AGENDA SECTION: PUBLIC HEARINGS	ORIGINATING DEPT: PLANNING	ITEM NO. <b>E-12</b>
ITEM DESCRIPTION: Final Plat #02-28 by Denny Peterson to be known as Pine Ridge Estates Fifth Subdivision. The Plat proposes to subdivide approximately 20.98 acres of land into 37 lots for single family detached dwellings and 1 outlot for a future park. The plat also dedicates the right-of-way for new public roadways. The property is located east and north of Ponderosa Drive SW and allows for the continuation of Red Pine Avenue SW.		PREPARED BY: Theresa Fogarty, Planner

# PINE RIDGE ESTATES FIFTH SUBDIVISION

**RE: Final Plat #02-28 by Denny Peterson to be known as Pine Ridge Estates Fifth Subdivision. The Plat proposes to subdivide approximately 20.98 acres of land into 37 lots for single family detached dwellings and 1 outlot for a future park. The plat also dedicates the right-of-way for new public roadways. The property is located east and north of Ponderosa Drive SW and allows for the continuation of Red Pine Avenue SW.**

**RE: PINE RIDGE ESTATES FIFTH  
FINAL PLAT #02-28**

PINE RIDGE ESTATES FIFTH SUBDIVISION

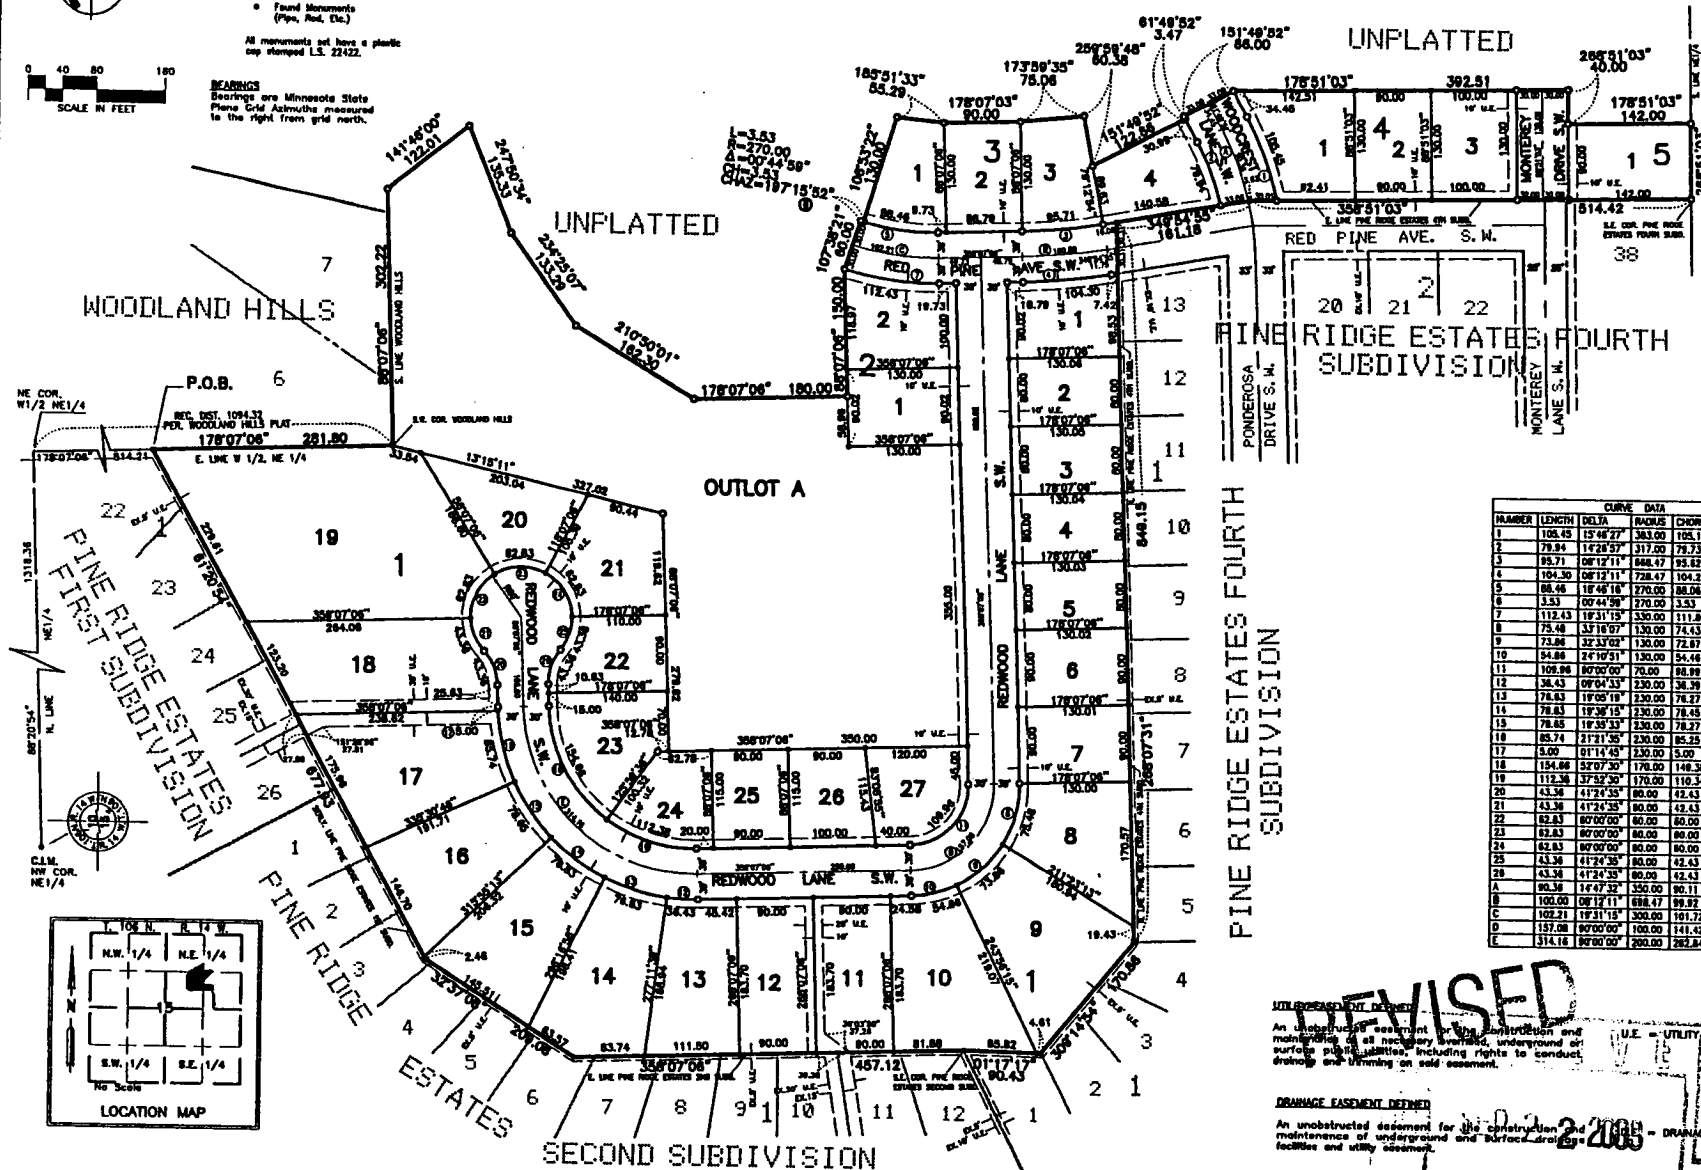
The second roadway labeled "Red Pine Avenue SW" is a continuation from the south and is designed with a 60' right-of-way. The roadway type for Red Pine Avenue SW north of the intersection with Redwood Lane SW needs to be changed. Change that portion of Red Pine Avenue SW to "Red Pine Lane SW".

The third roadway labeled as "Woodcrest Lane SW" is designed with a 66' right-of-way. This roadway needs to be changed as it is likely the roadway will not connect to the existing Woodcrest Lane SW further to the north in Woodland Hills Subdivision. Change the roadway within this plat to "Ponderosa Place SW"

The fourth roadway labeled as "Monterey Drive SW" is designed with a 60' right-of-way. This is an incorrect roadway type. Change Monterey Drive SW to "Monterey Street SW".

1. Monterey Drive SW is using an incorrect roadway type.

2. Red Pine Avenue north of its intersection with Redwood Lane SW also needs the roadway type changed.

3. Woodcrest Lane SW as platted, needs be changed as it is likely the roadway will not connect to the existing Woodcrest Lane SW further to the north in Woodland Hills Subdivision.

1. *Prior to recording, the final plat shall be revised, as follows:*
  - a. *Rename the roadway labeled Monterey Drive SW to "Monterey Street SW".*
  - b. *Change the portion of Red Pine Avenue SW north of the intersection with Redwood Lane SW to "Red Pine Lane SW".*

- c. *Rename Woodcrest Lane SW to "Ponderosa Place SW".*
2. *A GIS Impact Fee and E911 Addressing Fee shall be assessed and must be paid prior to recording the final plat, per the September 25, 2003 memorandum from Rochester-Olmsted Planning Department – GIS Division.*

**RECOMMENDATION:** Change Monterey Drive SW to **MONTEREY STREET SW**.

**RECOMMENDATION:** Change that portion of Red Pine Ave SW to **RED PINE LANE SW**.

**RECOMMENDATION:** Change Woodcrest Lane SW in this plat to **PONDEROSA PLACE SW**.
